ALLOCATION PROBLEMS OF SECOND AND THIRD CHANNEL
FM RADIO STATIONS (LPFM) IN THE VICTORIA,
TEXAS, RADIO MARKET

SUBMITTED AS ADDENDUM TO REPLY COMMENTS
IN RM-9242
BEFORE THE
FEDERAL COMMUNICATIONS COMMISSION

ADDENDUM 21

EXHIBIT E.R.C. (1)

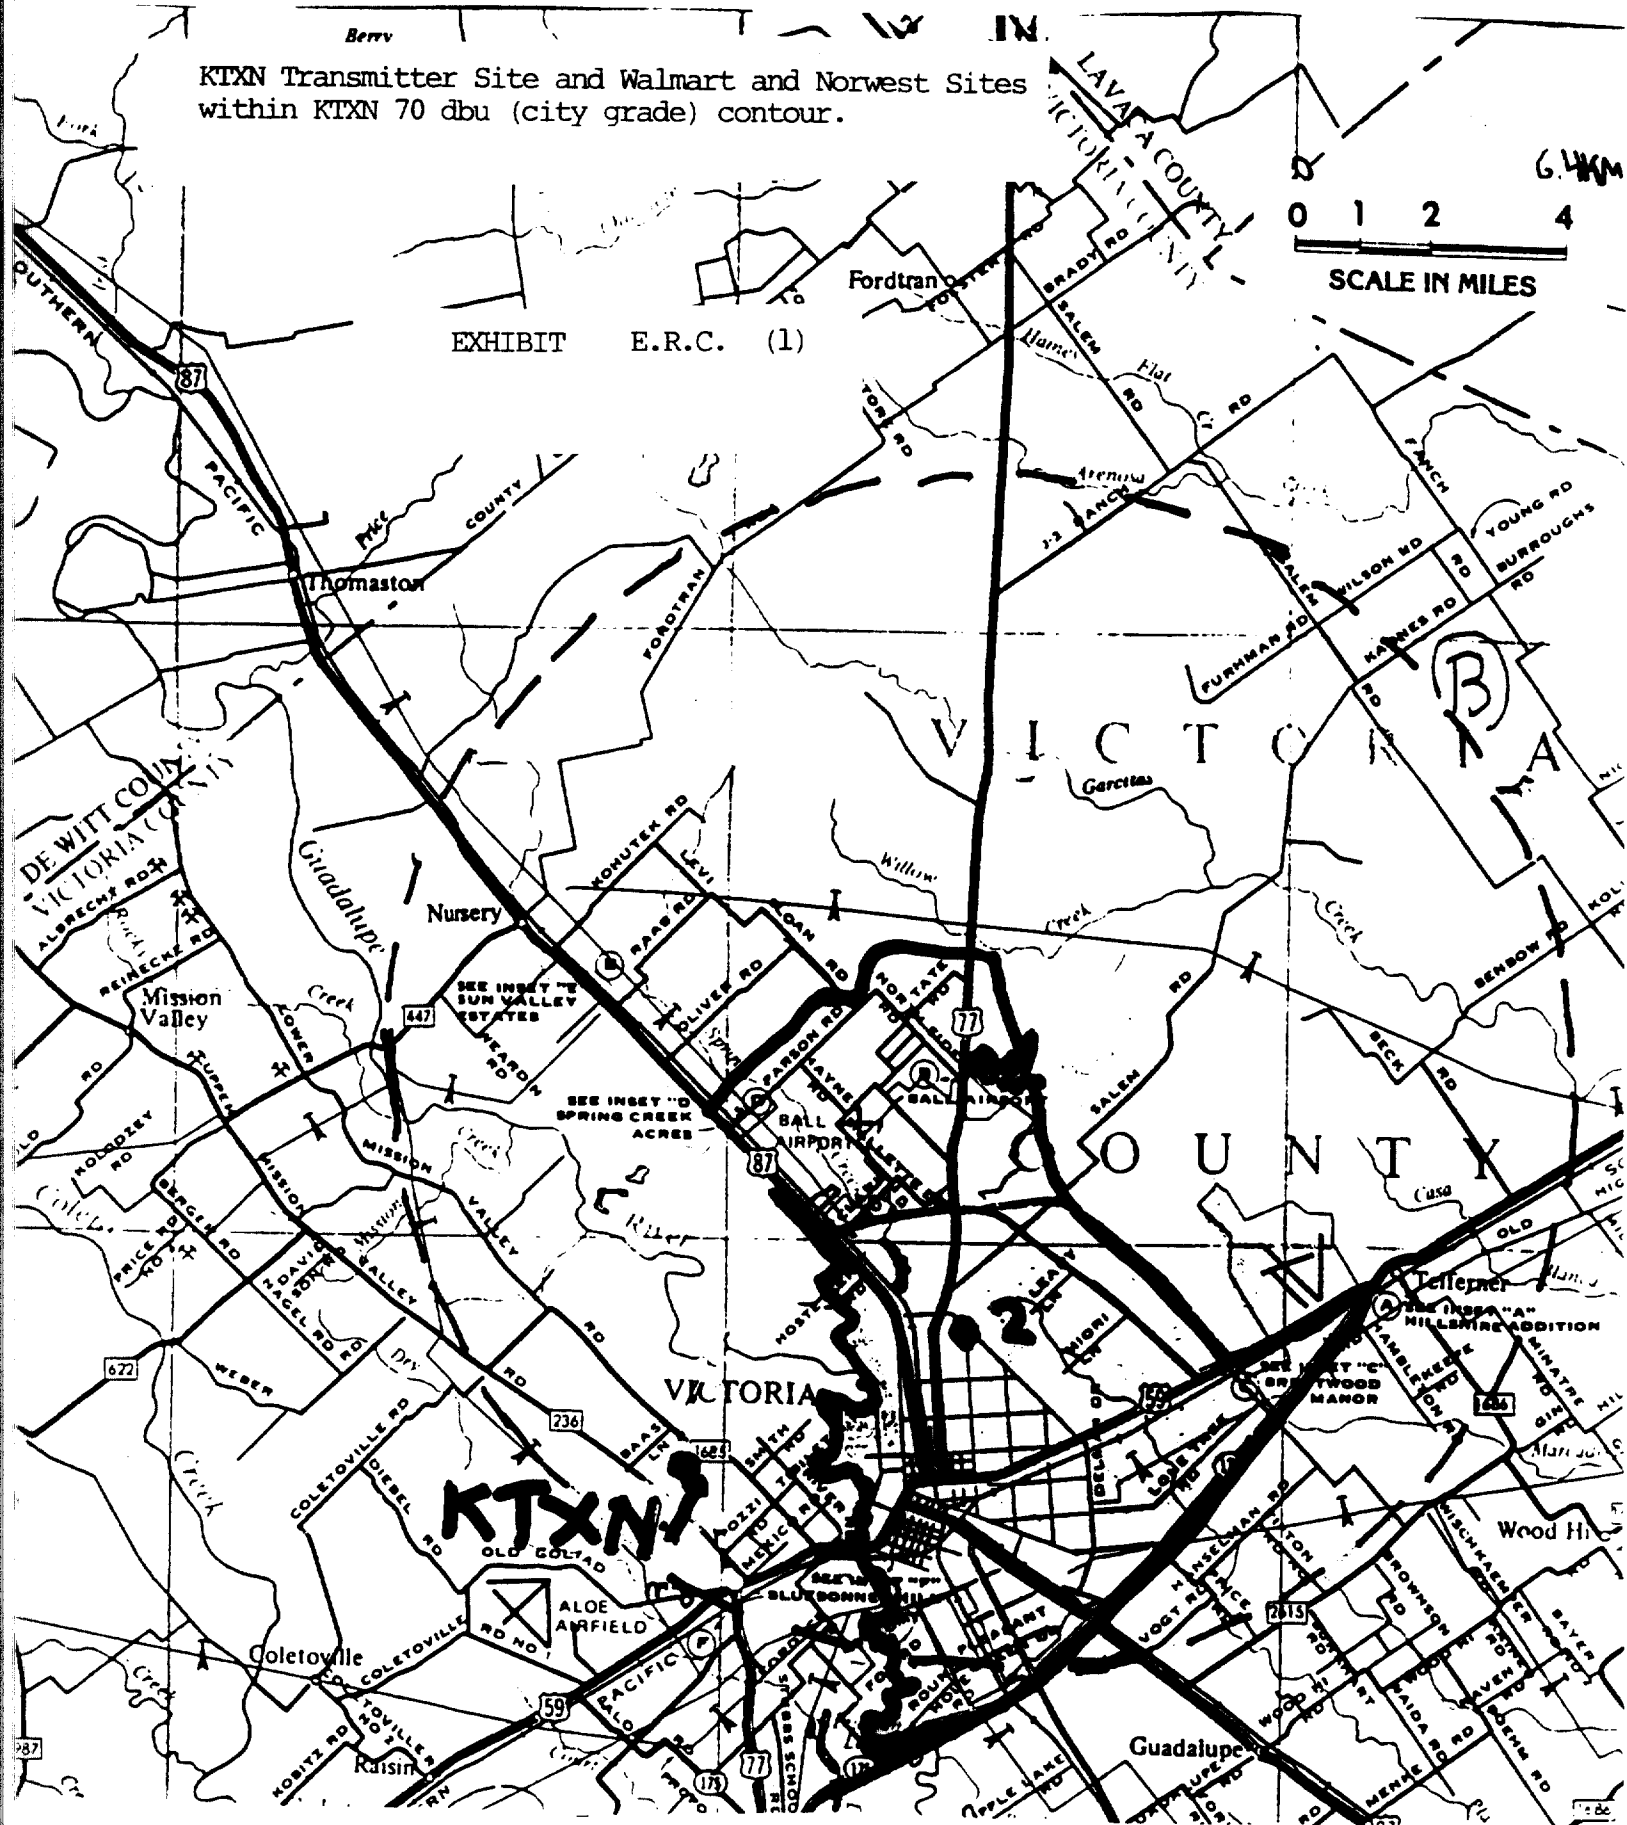
KTXN Transmitter Site and Walmart and Norwest Sites
within KTXN 70 dbu (city grade) contour.

WALMART IMPACT

AREA LOST
445 mi²
1153 KM²

NORWEST IMPACT

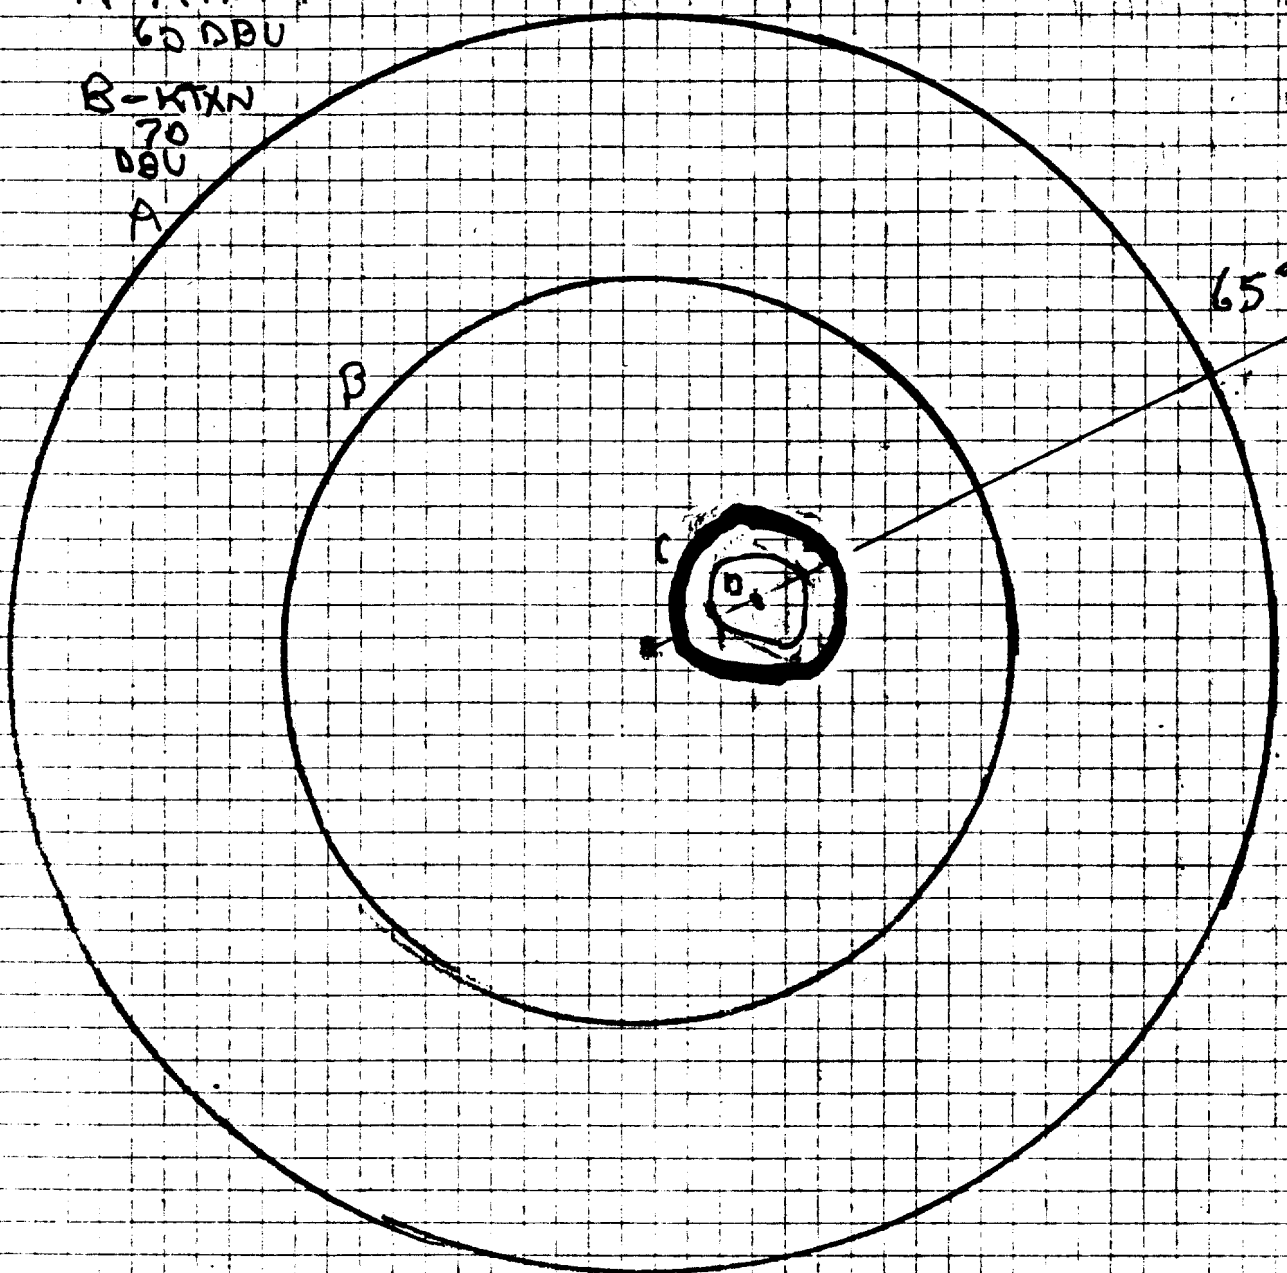
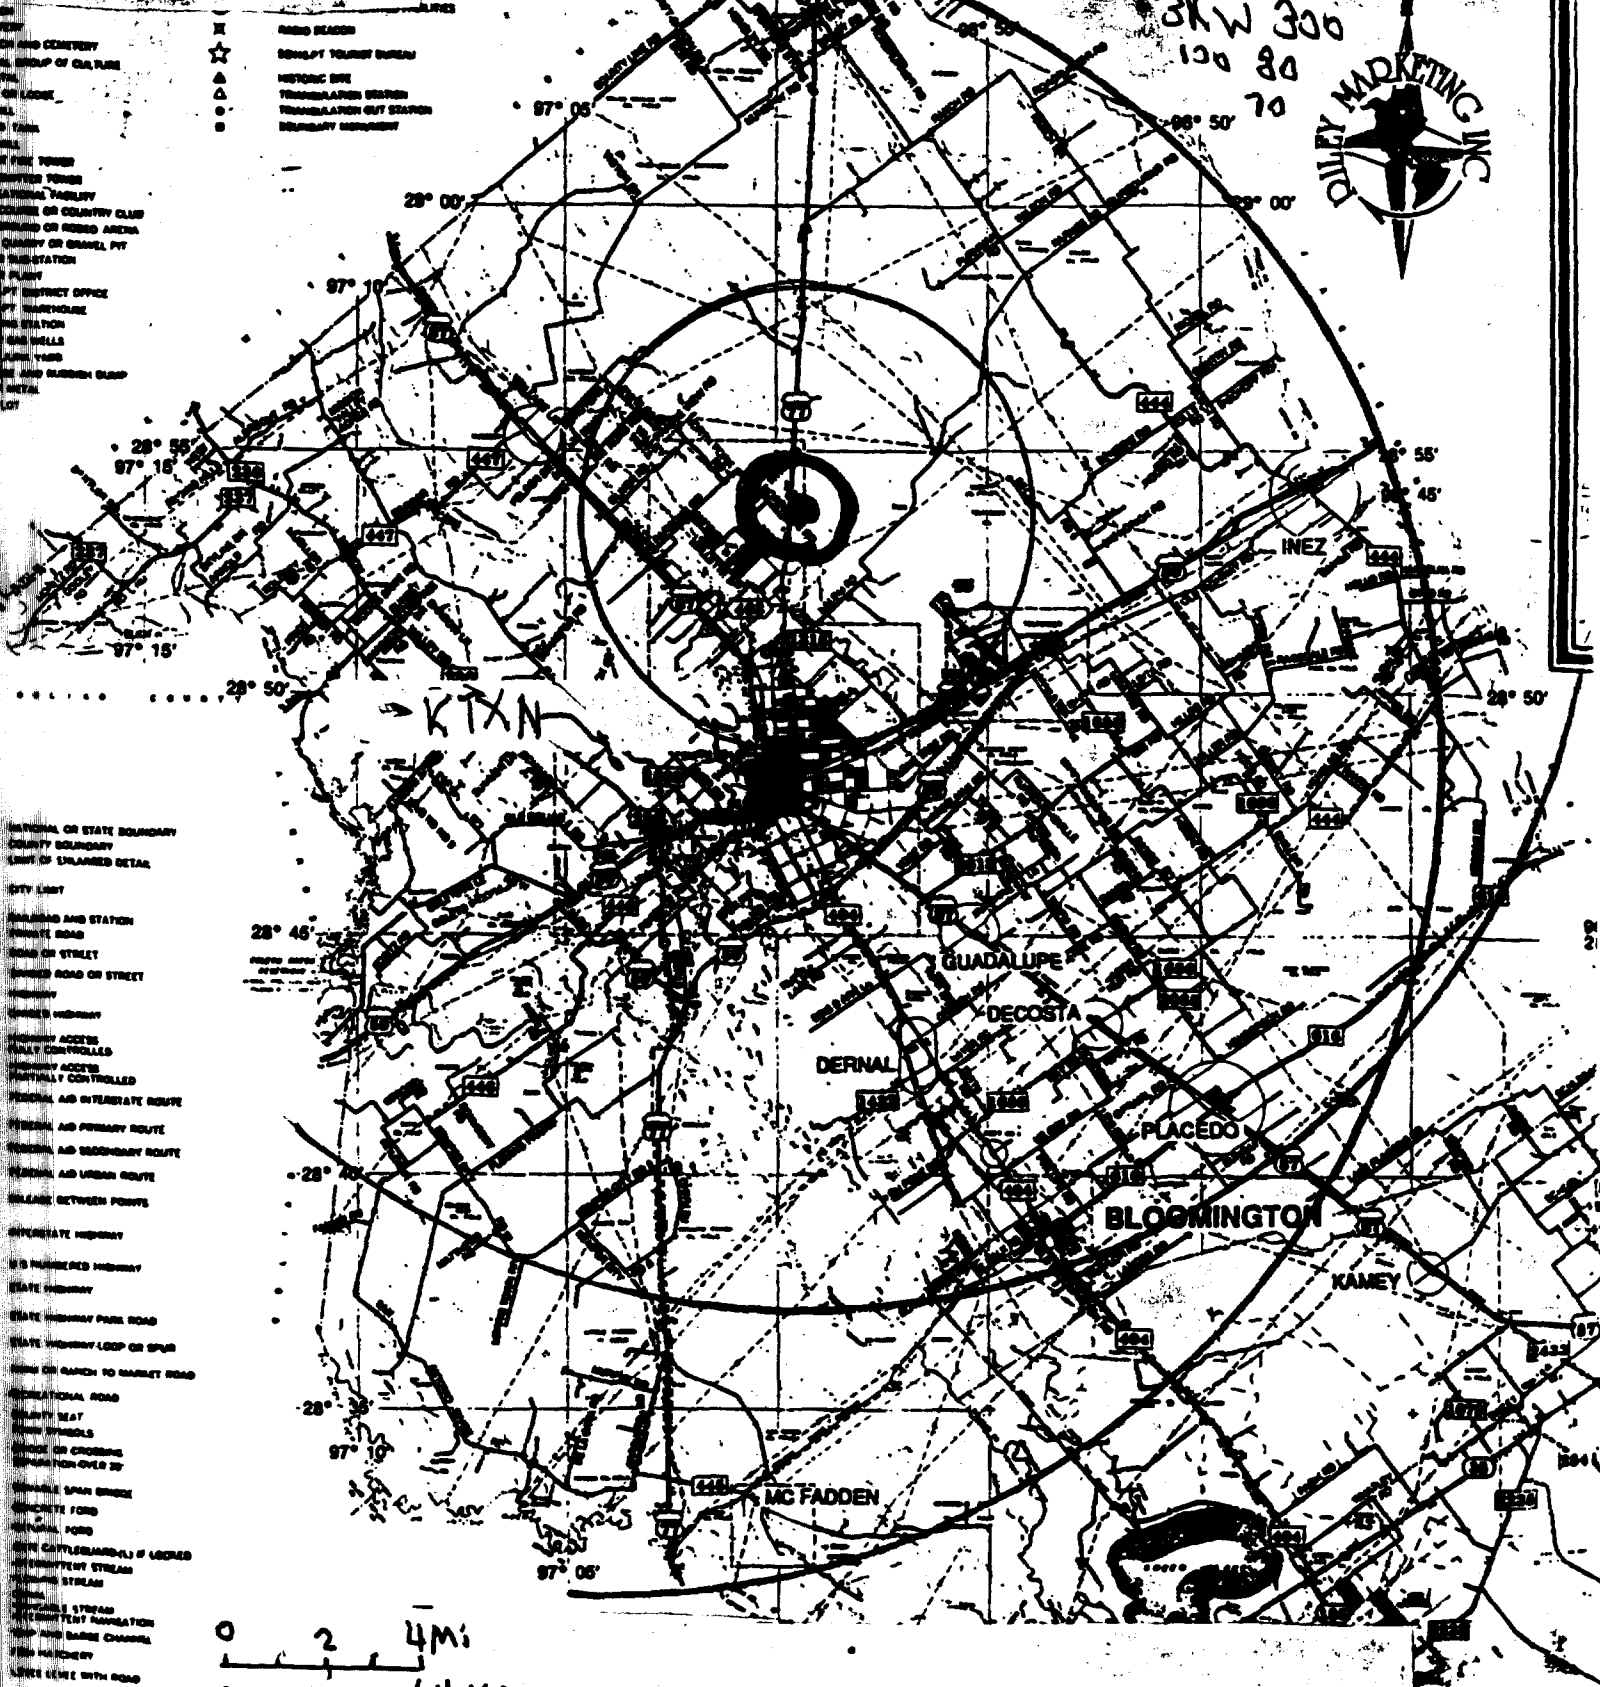
1 KW 150' (46M)
LOSS TO KTXN
830 KM²

EXHIBIT E.R.C. (6)

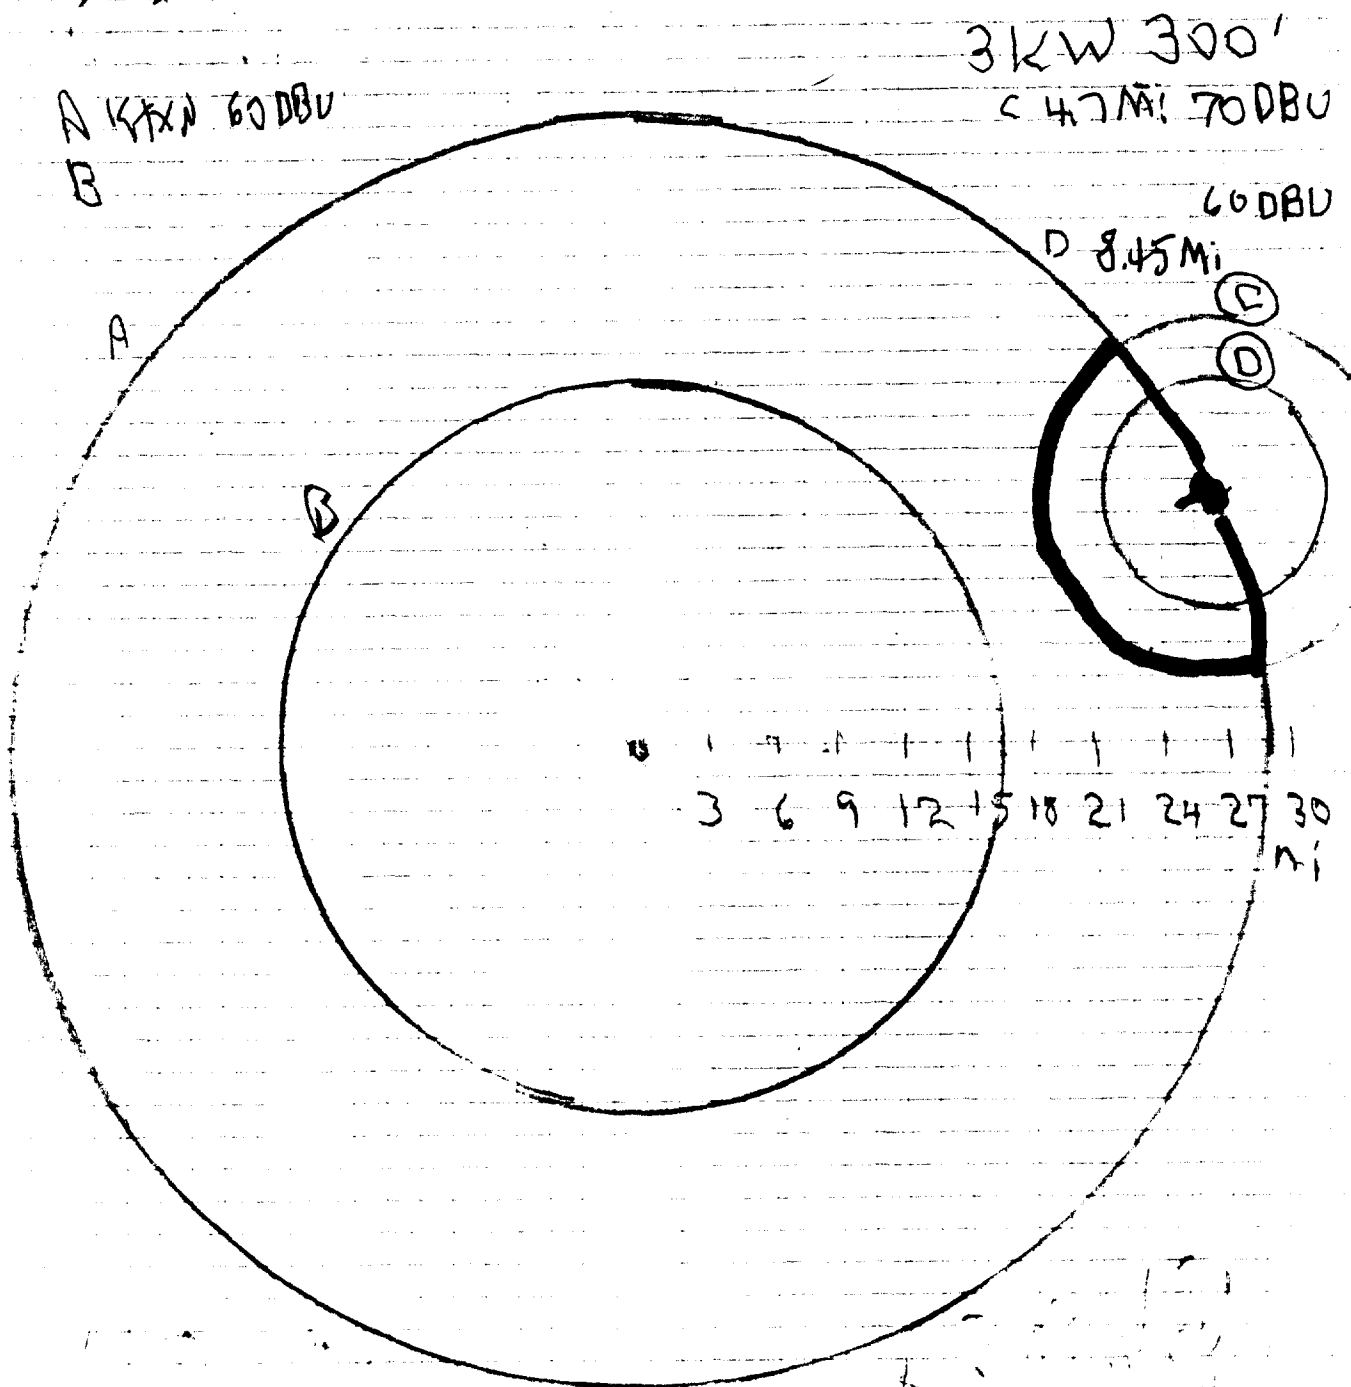
Proposed Edna, Texas, LPFM at 28 Mi (45 km)
at bearing of 65° true. and impact on KTXN
60 dbu contour.

LOSS TO KTXN
35% - mi.²
1527 km²

LOSS TO EDNA
50%
